INITIAL FIRE SAFETY INSPECTION REPORT

Styrax Fashions Ltd Plot 180

RSC ID: 26243

Address: Plot – 180 (Extension Zone), DEPZ, Ashulia, Savar, Dhaka, Bangladesh.

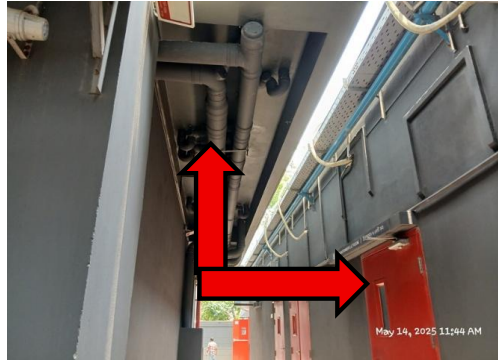
F-2	Means of Egress	<p>Storage room discharges directly into exit stair enclosure on 1st floor.</p> <p>Location: Main Building</p>	<p>Openings from exit enclosure to Storage areas/ basements/ transformer rooms/ generator rooms/ boiler rooms and similar normally unoccupied spaces shall be provided with a vestibule with fire rated construction and openings in accordance with section 6.14.3 of RSC Technical Guidelines (Standard)¹ V1.0.</p> <p>Provide a min 1-hr fire rated door on the exit stair side and a 1.5 hr. Fire rated door on the Store, generator, sub-station room side . Ensure that the fire rating of the vestibule construction matches that of the exit stair enclosure as per RSC Technical Guidelines (Standard)¹ V1.0. section 6.14.3. The minimum width for vestibules shall not be less than 1.1m and length 1.8m.</p>	Within 3 months
-----	-----------------	--	--	-----------------

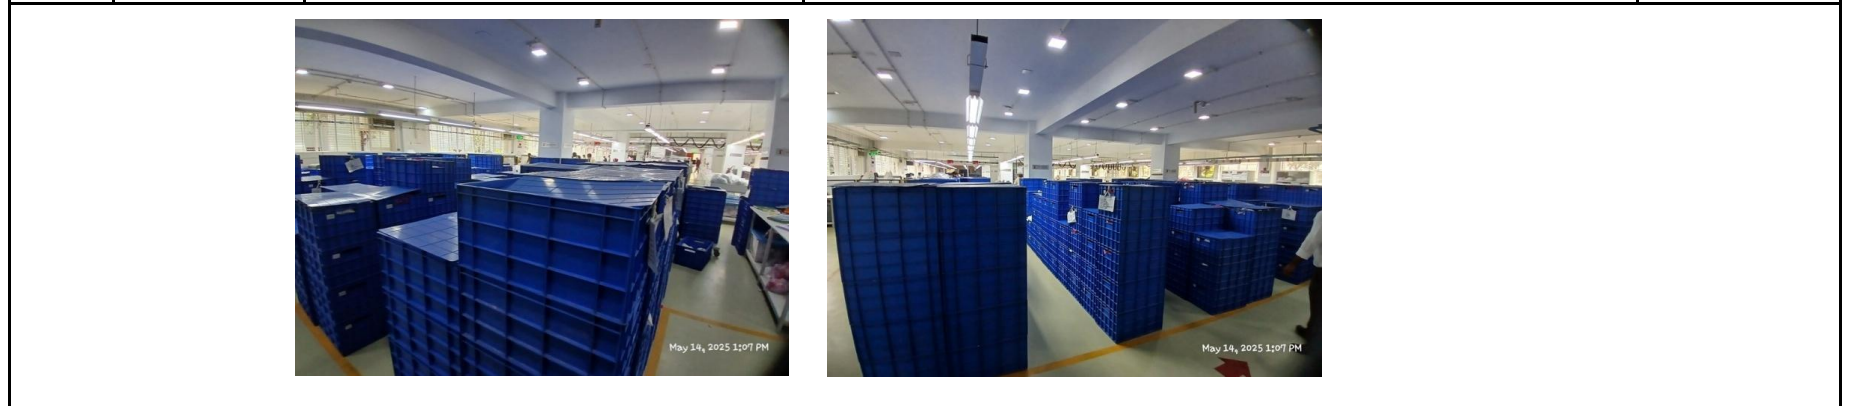
F-3	Fire Rated Construction	<p>Unsealed penetrations and openings are located in the fire-rated floor/ceiling assemblies due to electrical cable riser and plumbing pipe.</p> <p>Location: Basement and Ground floor of Main Building</p>	<p>Provide a minimum 2-hr fire-rated shaft to separate the utility risers from each floor level.</p> <p>Or, Seal all penetrations and openings in floors/ceiling assemblies by 3-hr fire-rated listed/certified materials. The installation of such fire-rated materials shall be following certified design and manufacturer's guidelines.</p> <p>Factory shall ensure that, all the design, datasheet, certificate, and proposed drawing of installation has been reviewed from the RSC prior to install the passive fire protection system (If required).</p>	Within 3 months
<div style="display: flex; justify-content: space-around;">   </div>
